**NUMBER:** 23-052-05

Rear Fascia To Body Side/Tail Lamp Fit

This bulletin involves adding two nut and bolt attachments to the rear fascia.

2005 - 2006 (LX/LE) 300/Charger

**Fig. 1 FASCIA TO BODE SIDE/TAIL LAMP GAP**

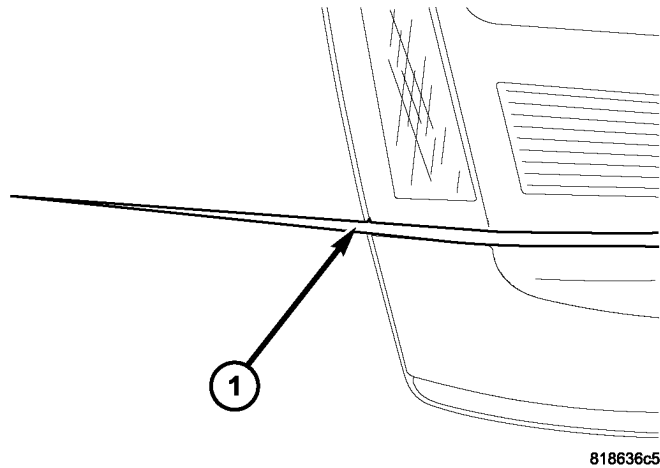
The gap between rear fascia and body side/tail lamp is more than 2mm (5/64 in).

If gap between rear fascia and body side/tail lamp measures more than 2mm (5/64 in), ([Fig. 1](#)), perform the Repair Procedure.

**Fig. 2 PUSH PIN LOCATION**

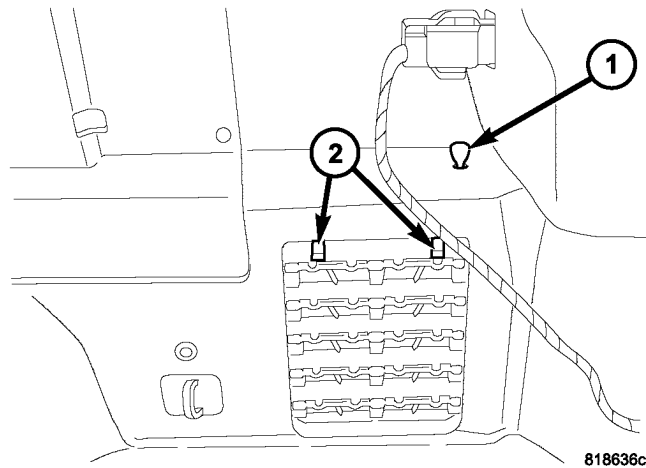
1. Open the trunk lid.
2. Pull the trunk carpet away from one side of the trunk.
3. Remove the push pin (located above and rearward of the body exhauster) attaching the fascia to the body side, by pushing out the center (white) pin with a punch, then push (black) body through hole, (Fig. 2). Pin and body will fall to the ground under the rear fascia.

4. Apply a drop of MOPAR Lock & Seal Adhesive, p/n 04318031, to the threads of bolt, p/n 06505546AA.
5. Insert bolt, p/n 06505546AA, downward through the push pin hole.
6. Remove the body air exhauster by pushing down on the retaining tabs, and pushing the exhauster through opening.
7. Hand start nut, p/n 06104726AB, onto the bolt through the exhauster opening.
8. Tighten the nut and bolt to 11 Nm (100 in. lbs.).
9. Install the body air exhauster.
10. Return the trunk side carpet to its original position.
11. Repeat steps 2-10 for the other side repair.
12. Close the trunk lid.
